**RE: Remediation Work Plan  
OH Randel #5, API #30-045-05964  
Hilcorp Energy Company  
San Juan County, New Mexico**

**From:** Smith, Cory, EMNRD  
**Sent:** Friday, April 19, 2019 10:17 AM  
**To:** 'Clara Cardoza'  
**Cc:** Ashley Ager; Matt Henderson; Devin Hencmann  
**Subject:** RE: [EXTERNAL] RE: OH Randel #5 Delineation and Variance Request

**FIGURE 2**  
**PROPOSED SAMPLING MAP**  
**OH RANDEL #5**  
**NWNW SEC 10 T26N R11W**  
**SAN JUAN COUNTY, NEW MEXICO**  
**HILCORP ENERGY COMPANY**

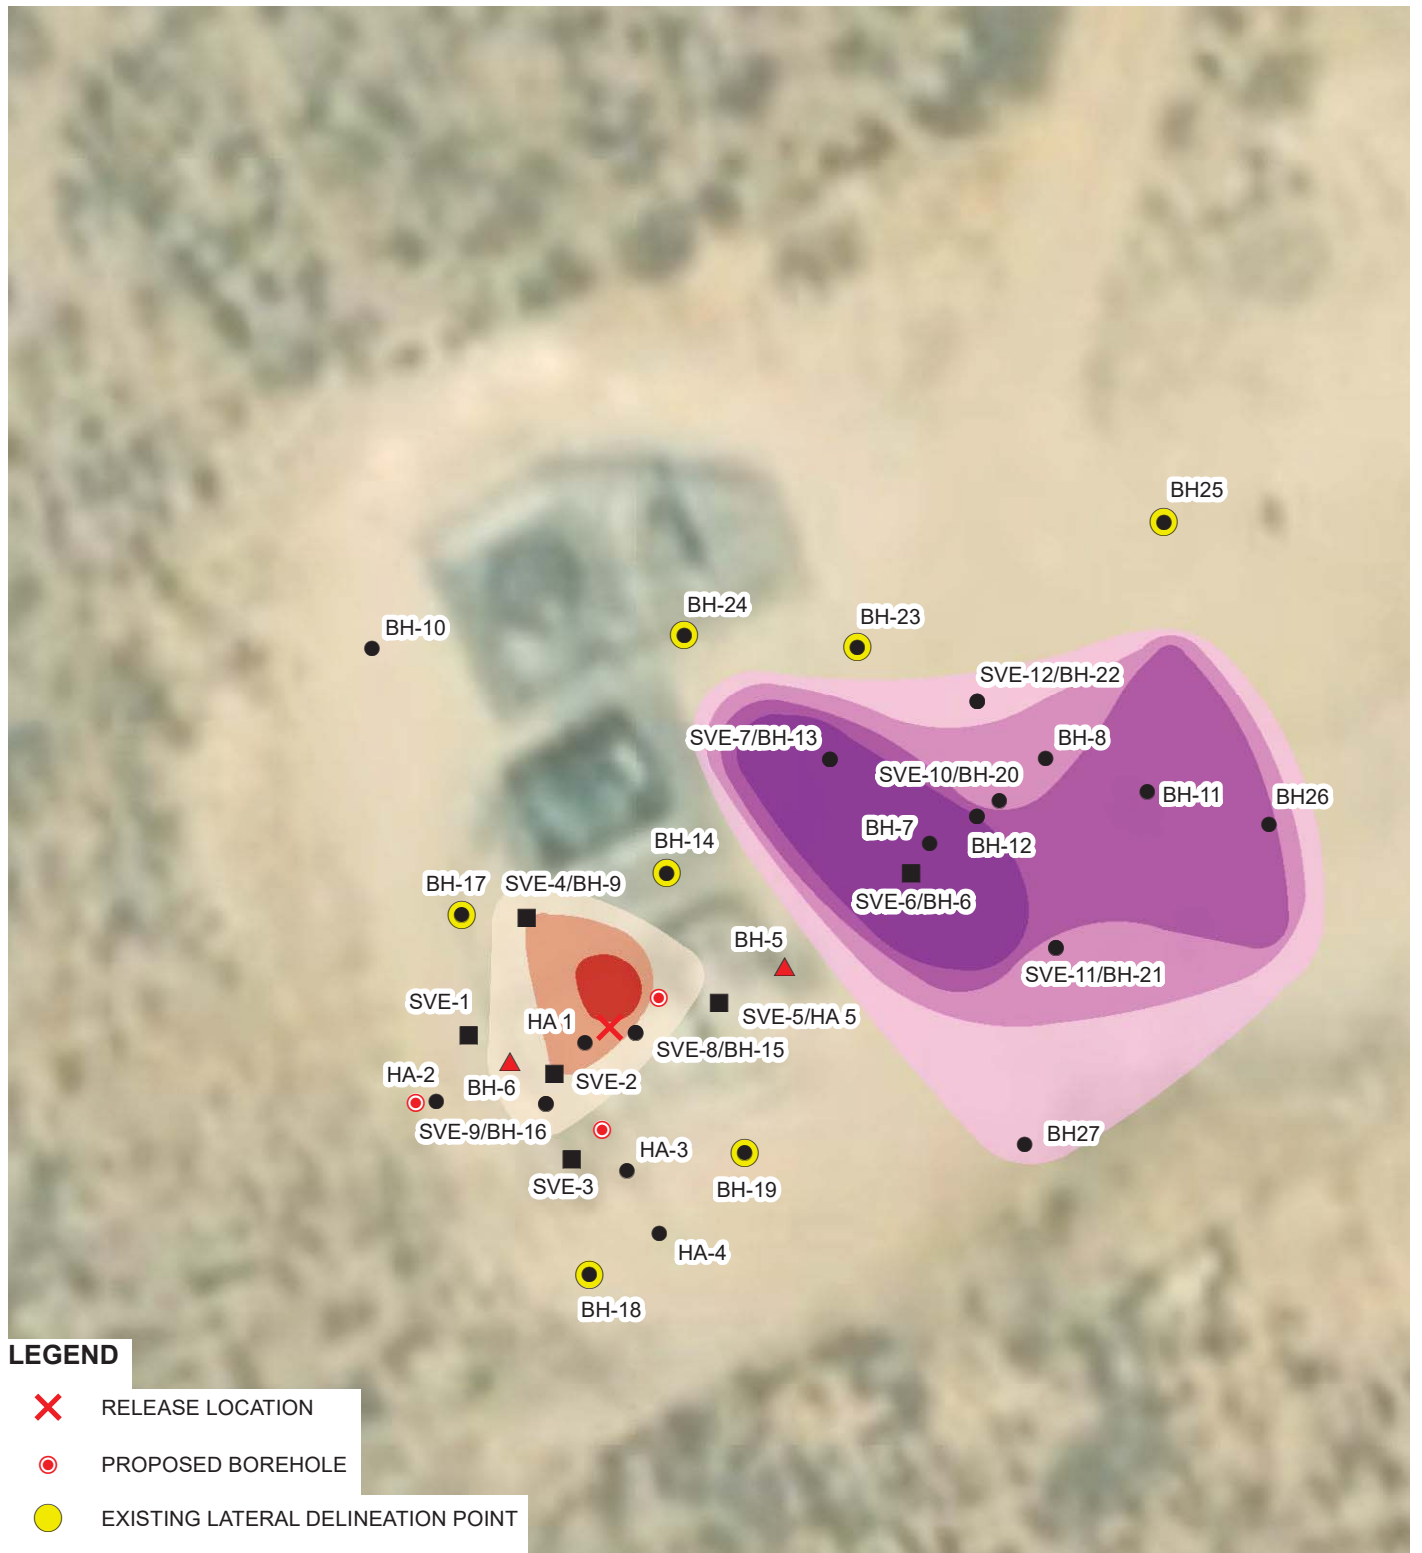
OCD approves the remediation plan with the following conditions

- HEC will either add or move a proposed borehole to be near the release location as depicted in figure #2.
- HEC will notify OCD at least 48 hours prior to the collection of confirmation samples.

The exact location of closure bore holes can be discussed onsite if needed.
